ADDENDUM NO. 05

RANKIN TRAILS AMPHITHEATER AND BASEBALL PARK

Rankin County, Mississippi

WBA Proj. # 2215/2315

SK.001

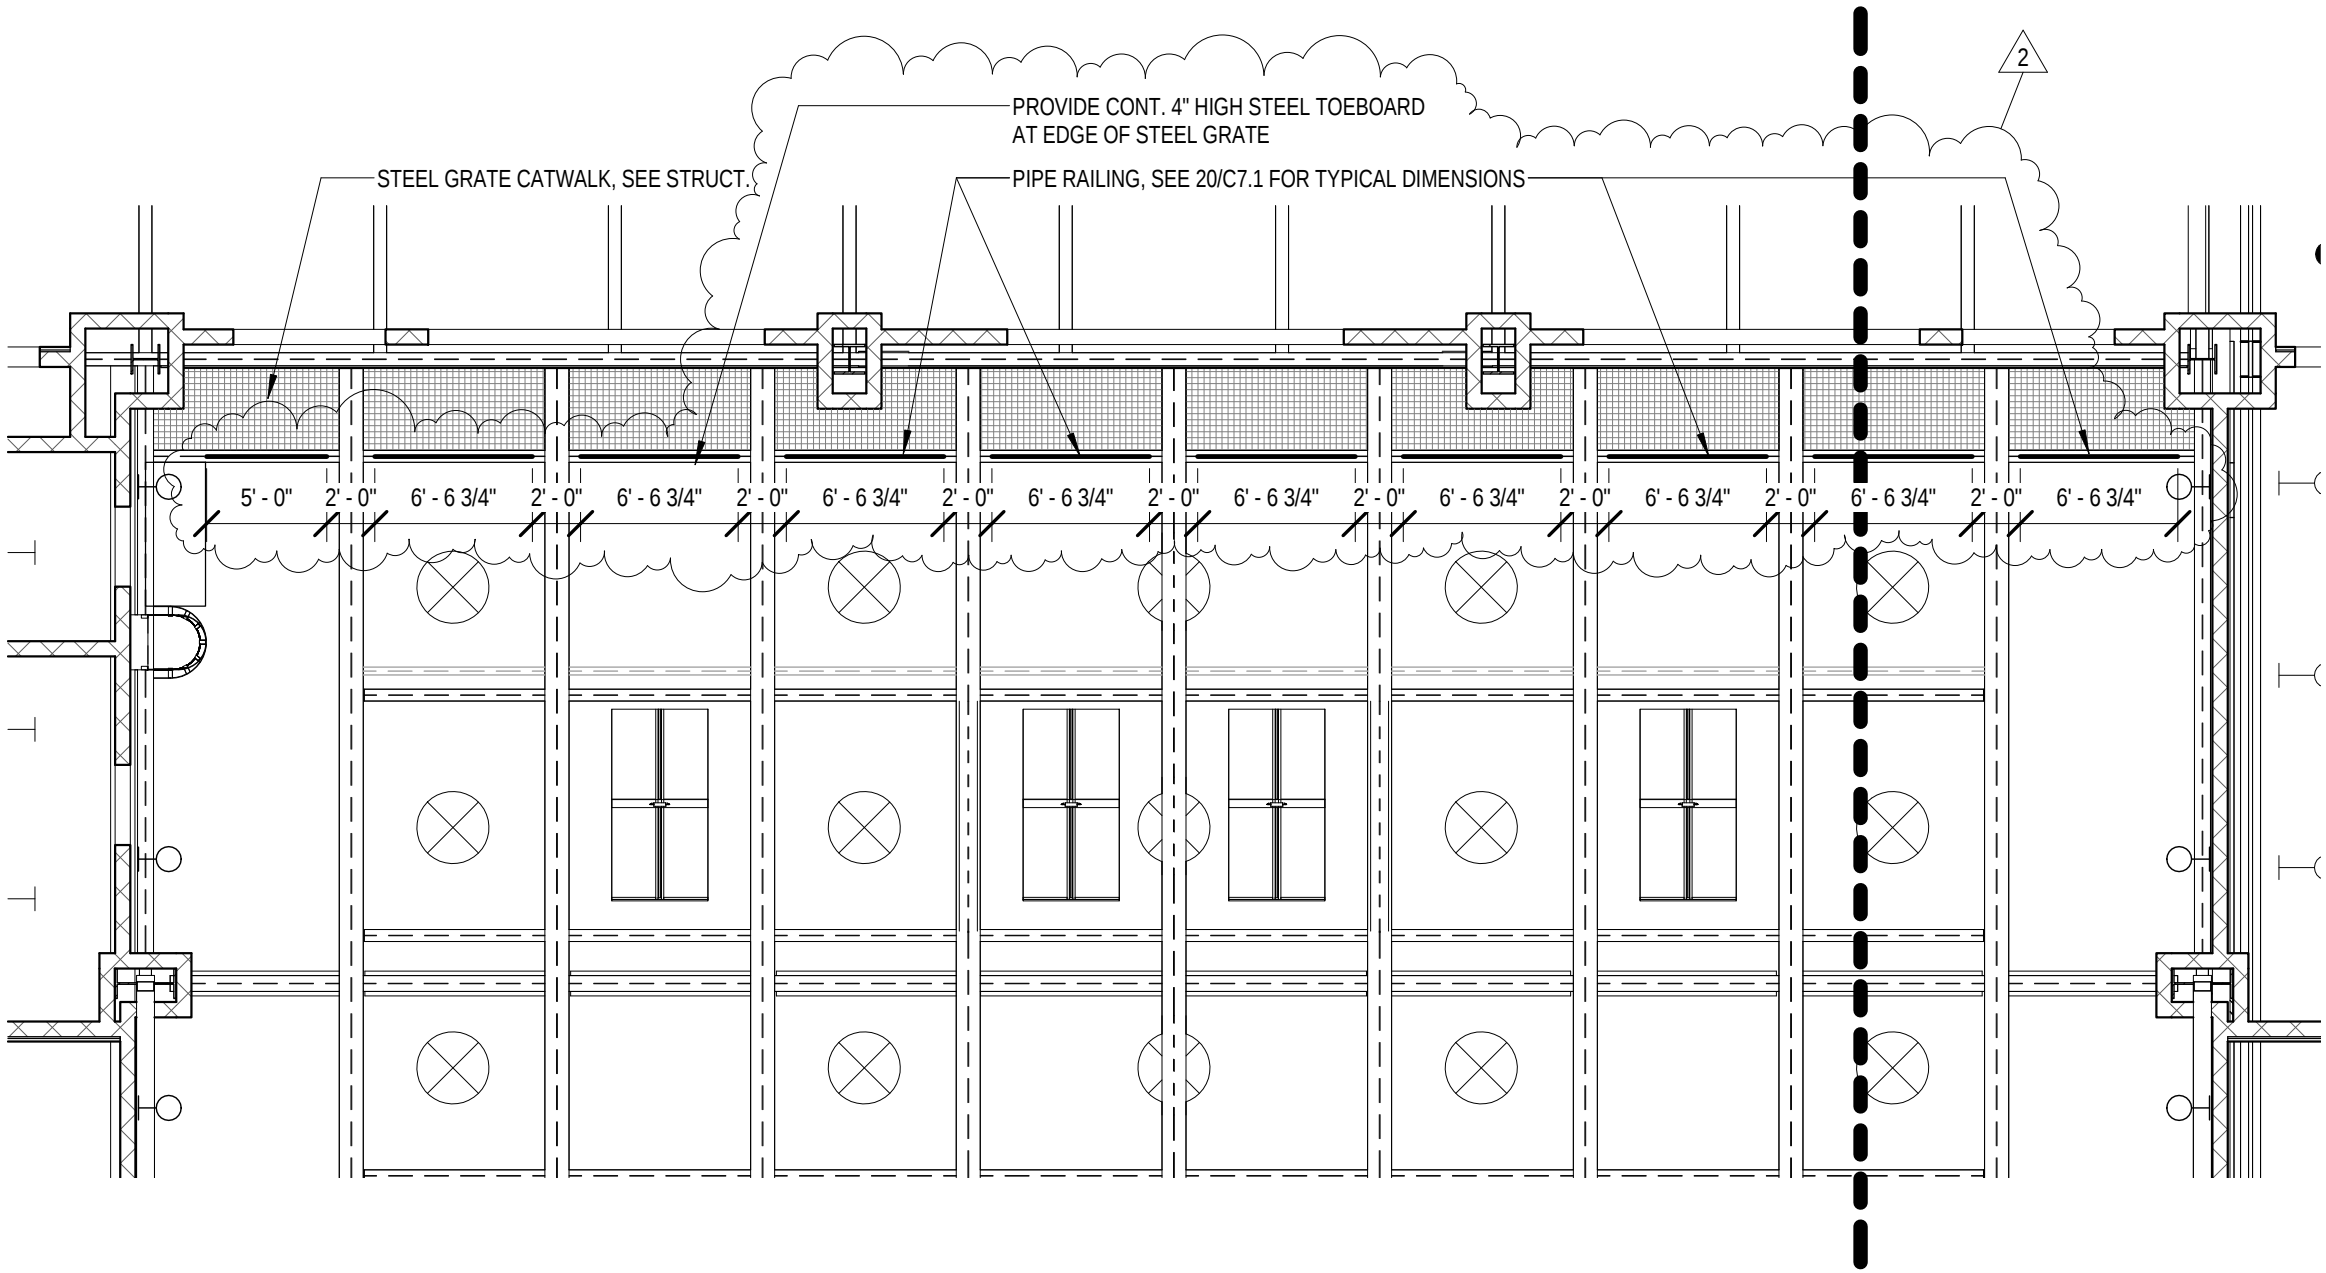
- ITEM NO. 9** **SHEET L2.3 SPORTS FIELD PLANT SCHEDULE**
ADD plants, bed preparation, and mulch behind dugouts, per enclosed sheet L2.3.
- ITEM NO. 10** **SHEET A2.2**
ADD pipe and tube railing and steel toe-board, per enclosed sheet SK.001.

RAILING AT CATWALK

2 LINETEL SCHEDULES
S0.3 SCALE: N.T.S.

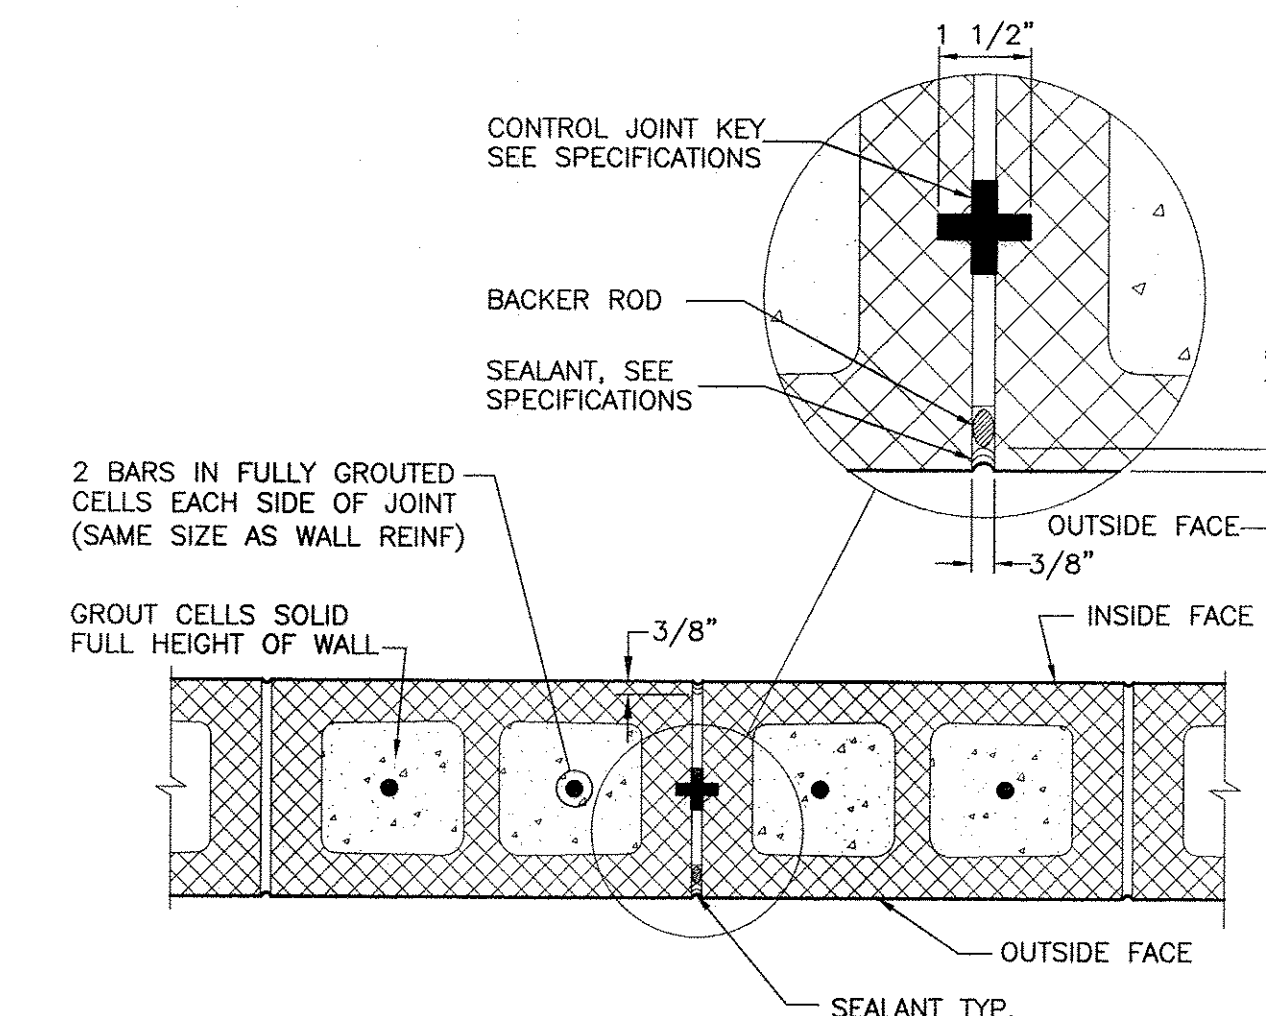
- REVISE door type and material on door schedule as follows:
Door #A58A from CWP to **HM** and Type E to **Type D**.
- ITEM NO. 12** **SHEET S0.3**
REVISE per enclosed sheet S0.3. Section reference corrected for angle lintel.

SHEET:
ADD5-E3

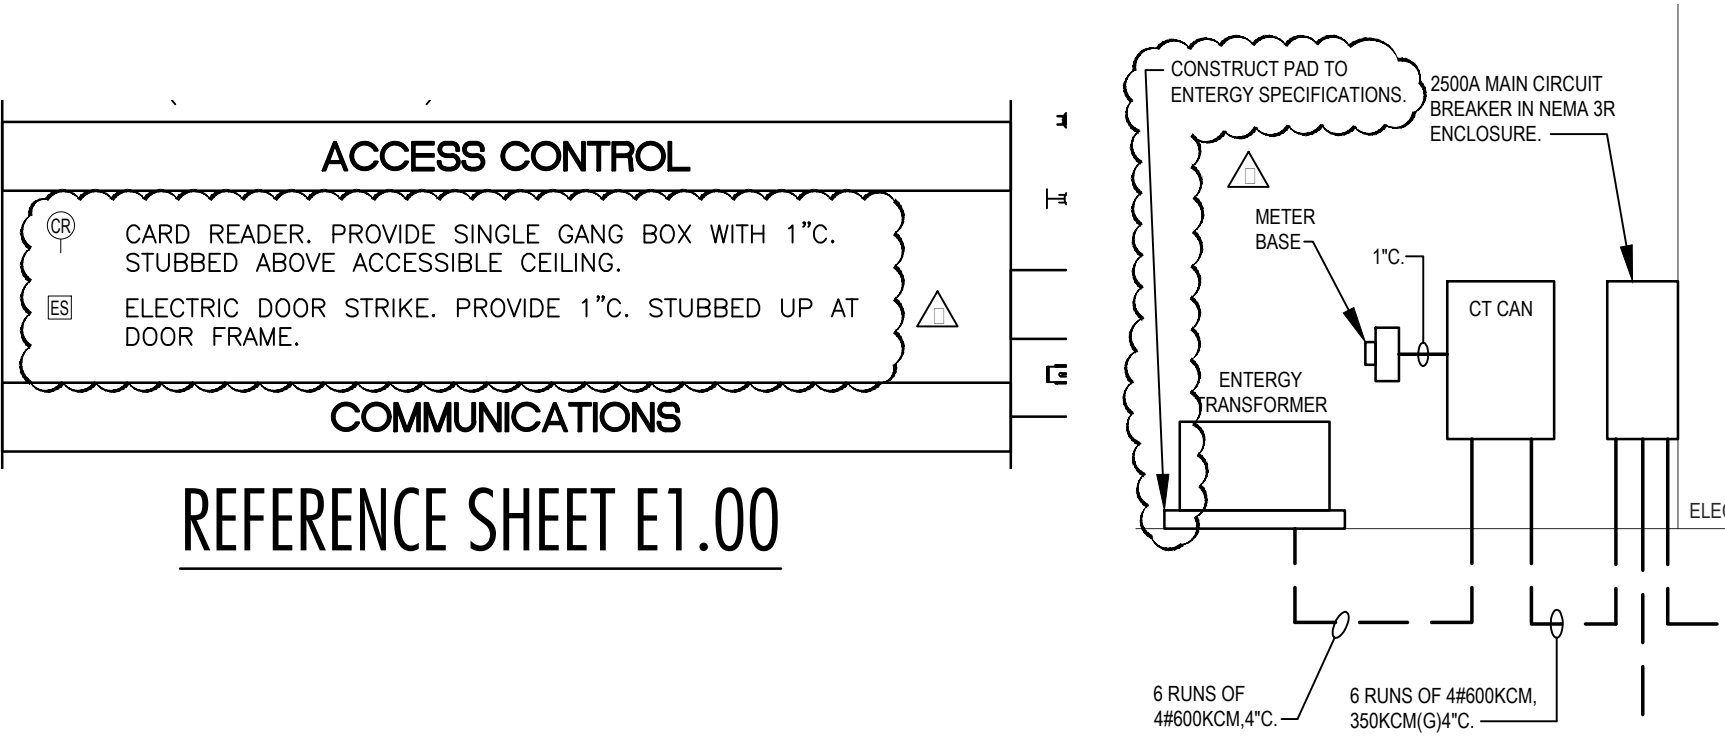
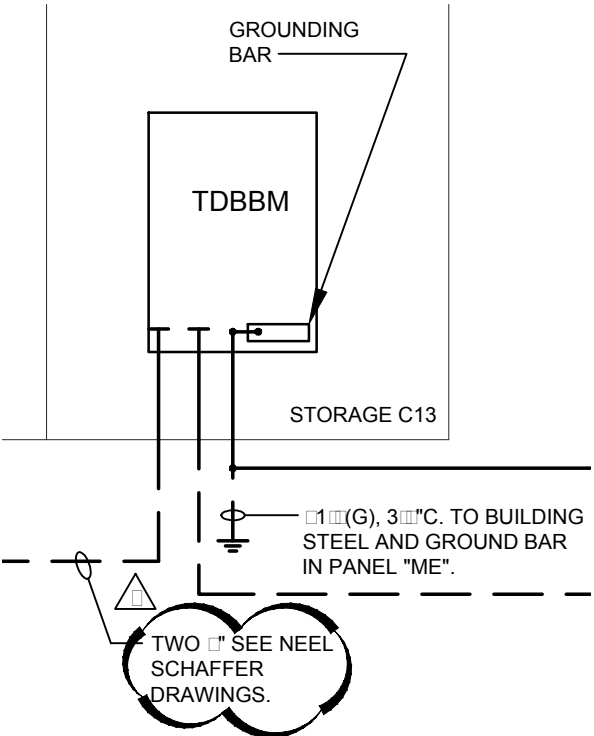
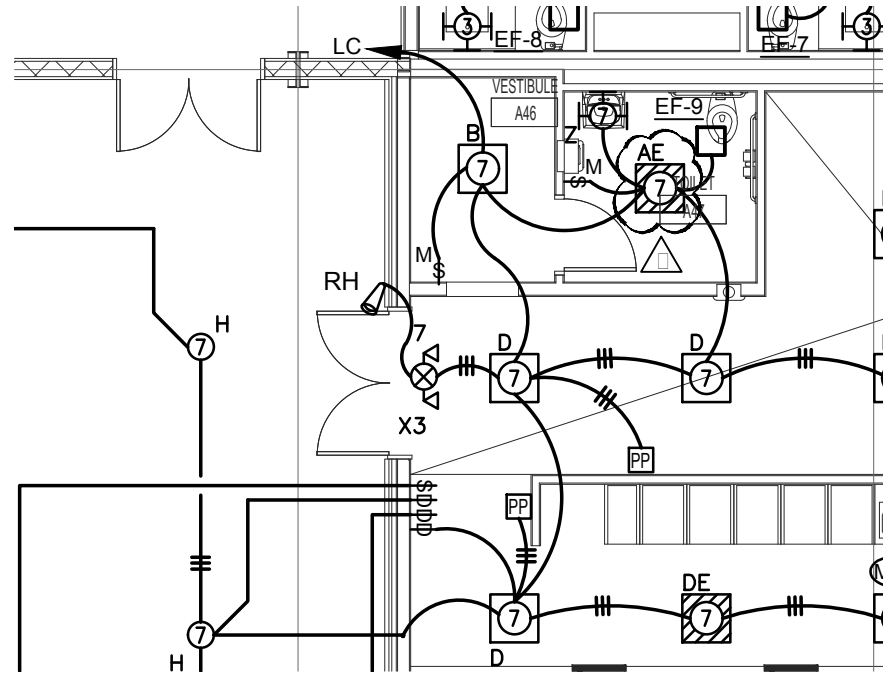
- ITEM NO. 13** **SHEET E1.03**
REVISE per enclosed sheet ADD5-E1.
- ITEM NO. 14** **SHEET E1.04**
REVISE per enclosed sheet ADD5-E2.
- ITEM NO. 15** **SHEET E1.04, E1.06**
REVISE per enclosed sheet ADD5-E3.

REFERENCE SHEET E1.10

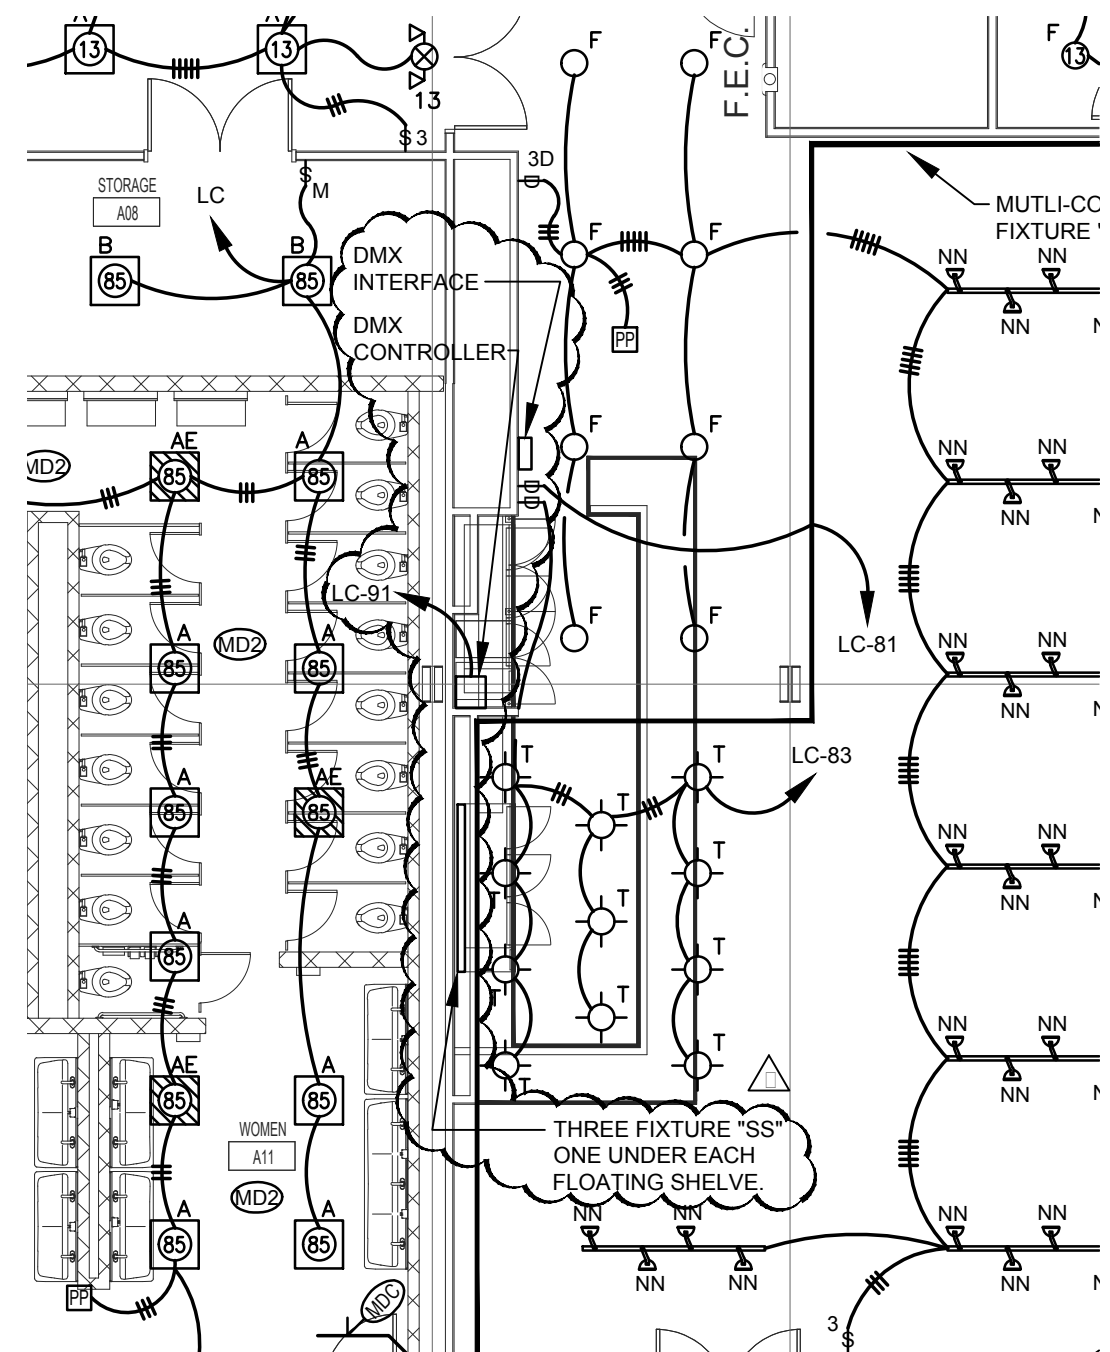
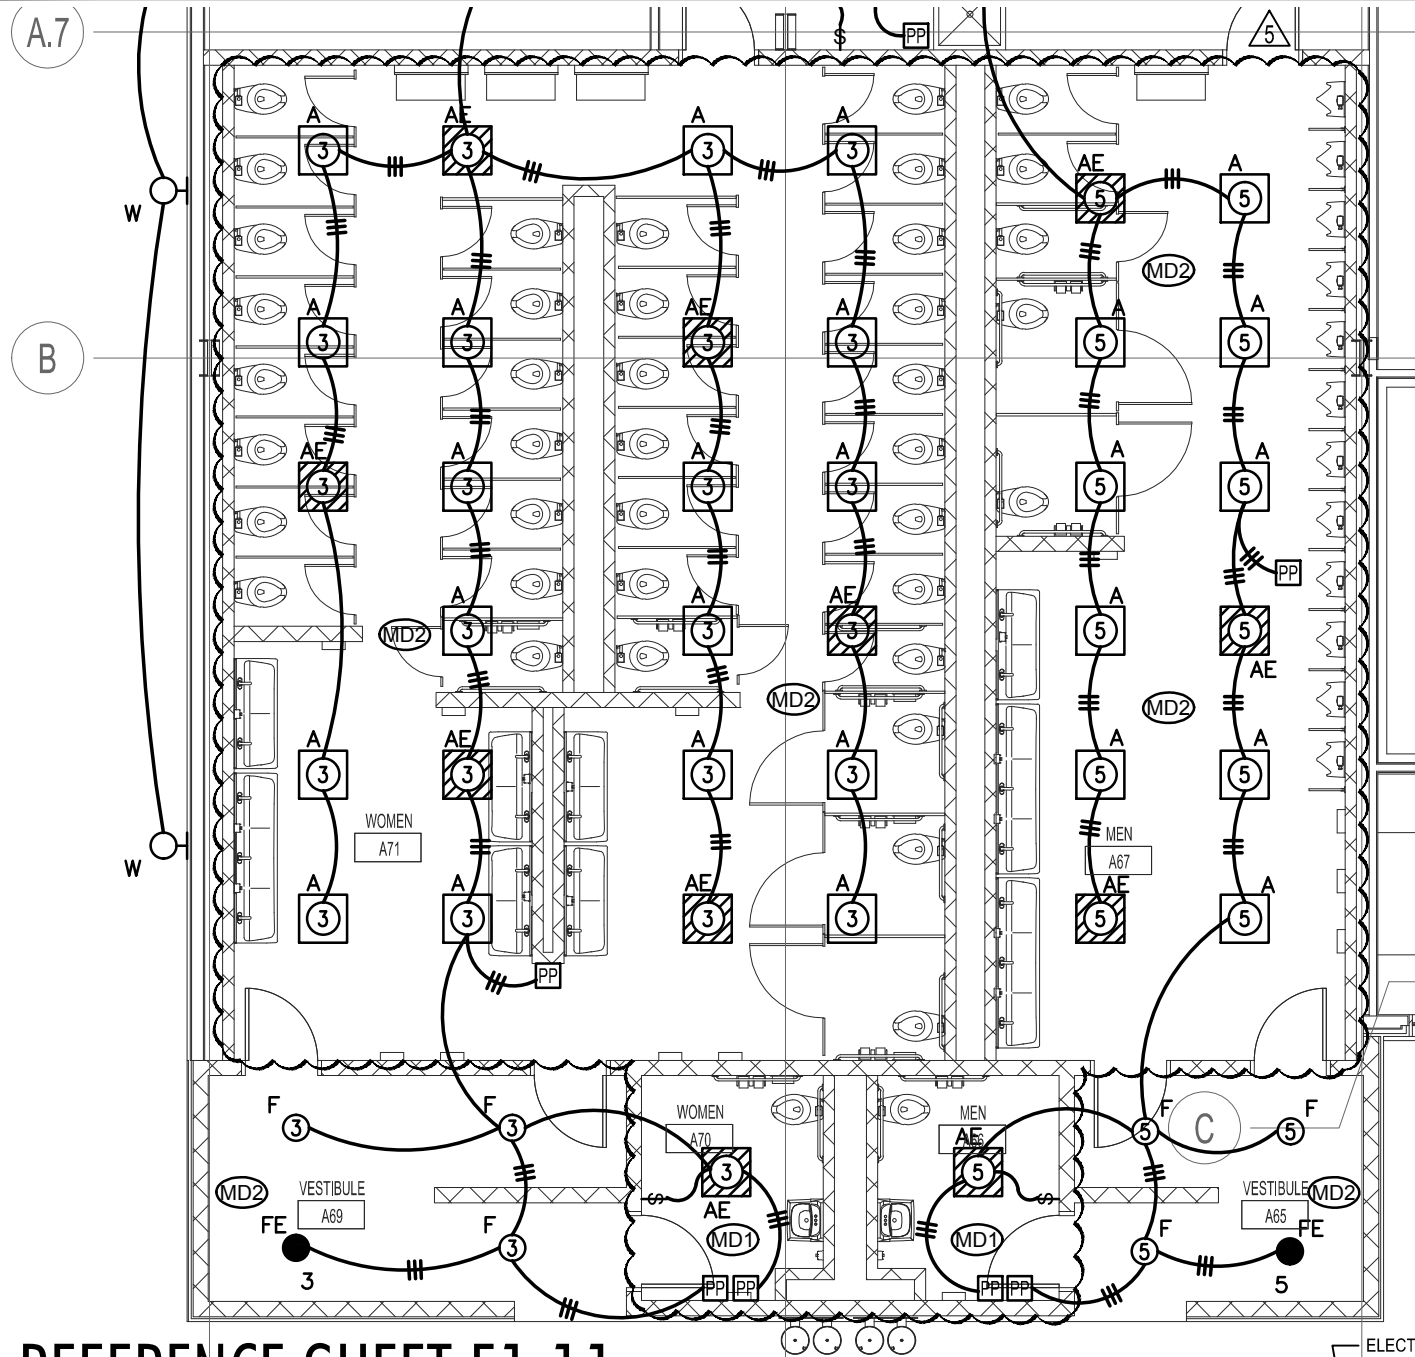
- ITEM NO. 16** **SHEET E1.10**
REVISE per enclosed sheet ADD5-E4.
- ITEM NO. 17** **SHEET E1.11, E1.12**
REVISE per enclosed sheet ADD5-E5.
- ITEM NO. 18** **SHEET E1.20**
REVISE per enclosed sheet ADD5-E6.
